Section 4.55(1A) Modification Application

SSD 49295711 MOD 1

Harbourside Shopping Centre Redevelopment – Podium and Tower

Submitted to Department of Planning, Housing and Infrastructure
on behalf of Mirvac

Figure 2 Typical low-rise floorplate – as approved (left) and as proposed to be amended (right) – level 14 shown

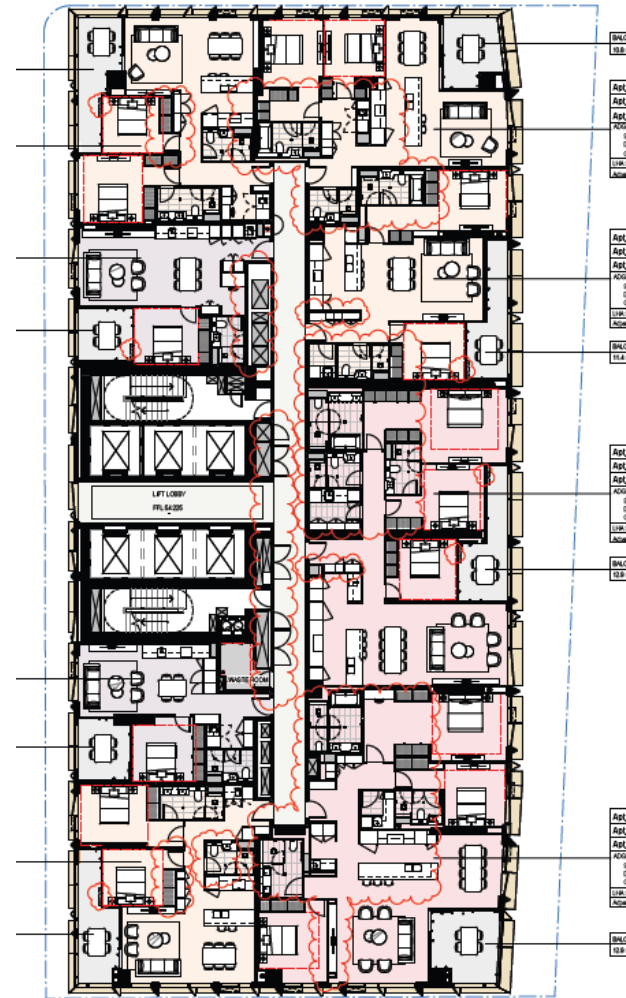
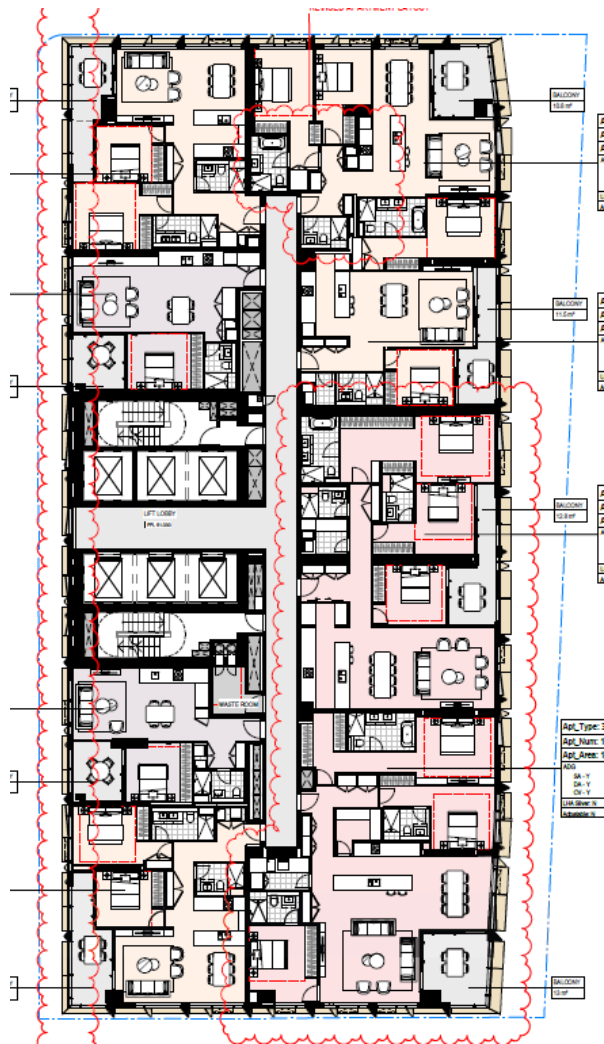
Design amendments are proposed to improve apartment layouts and account for further design development and services/engineering coordination that has occurred post-approval. The amendments are detailed in the Architectural Plans and accompanying Design Report, and specifically comprise:

- Adjustments to the internal planning of apartments;
- Adjustments to riser sizes and locations, and integration with maintenance access doors;
- Adjustments to window sizes and locations;
- Adjustments to spandrel positions;
- Refinement of facade horizontal fin profile;
- Relocation and refinements to Silver Liveable and Adaptable apartments; and
- Conversion of 13 3-bedroom + study apartments into 4-bedroom apartments, as further described in **Section 3.2**.

Excerpts from the Architectural Plans showing typical amendments to floorplate layout is provided in **Figures 2 – 4** below.

Figure 3 Typical mid-rise floorplate – as approved (left) and as proposed to be amended (right) – level 29 shown

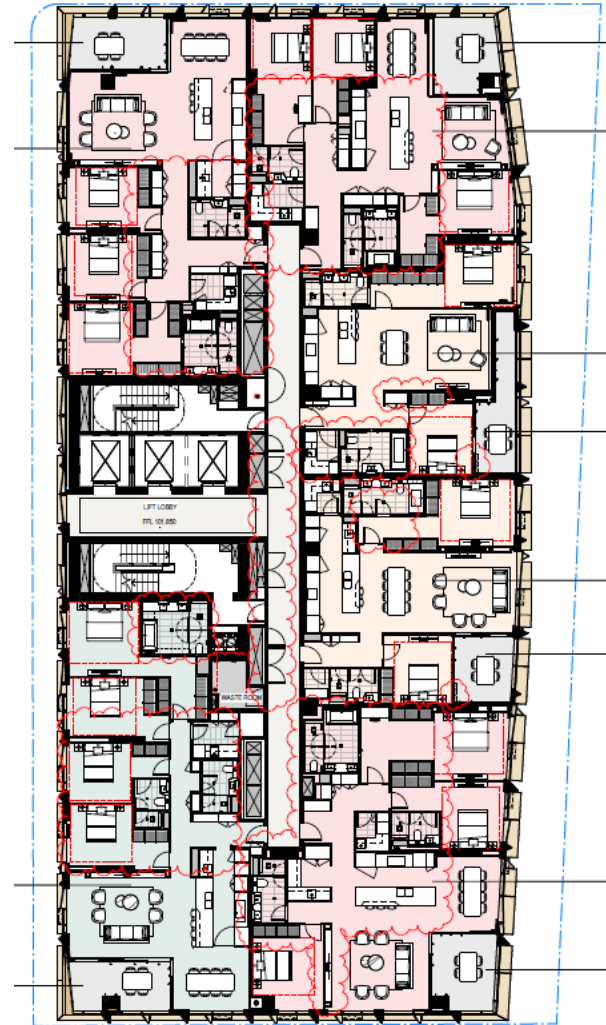
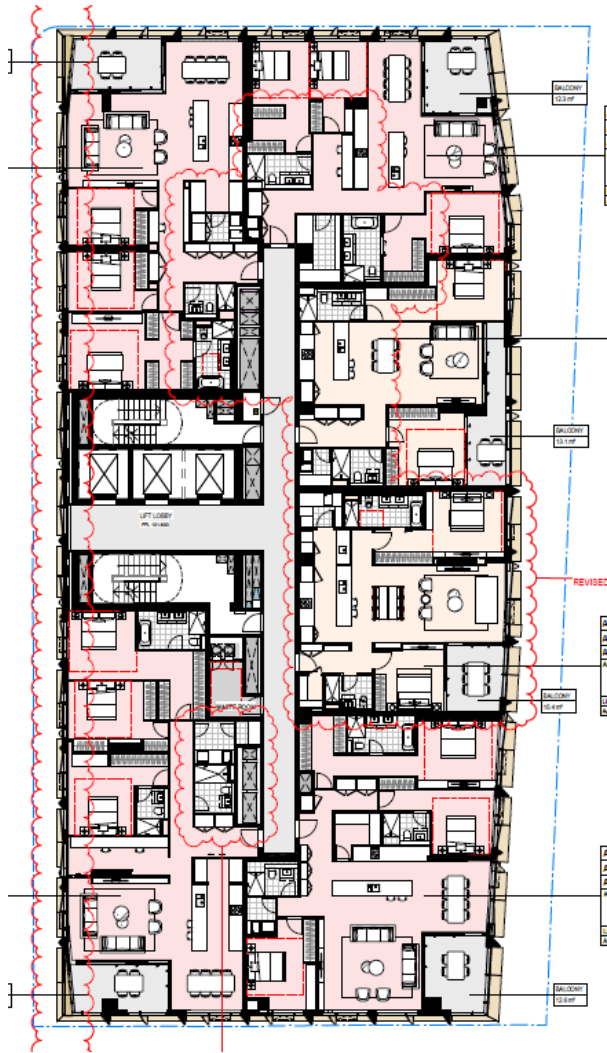
Adjustments are proposed to the unit mix as currently approved under SSD 49295711. Specifically, one 3-bedroom + study apartment on each floor of levels 29 – 41 (for a total of 13 levels) is to be converted into a 4-bedroom apartment. This has been made possible due to further post-approval design rationalisation and improvements in floorplate efficiency and does not change the total number of apartments (which remains at 265).
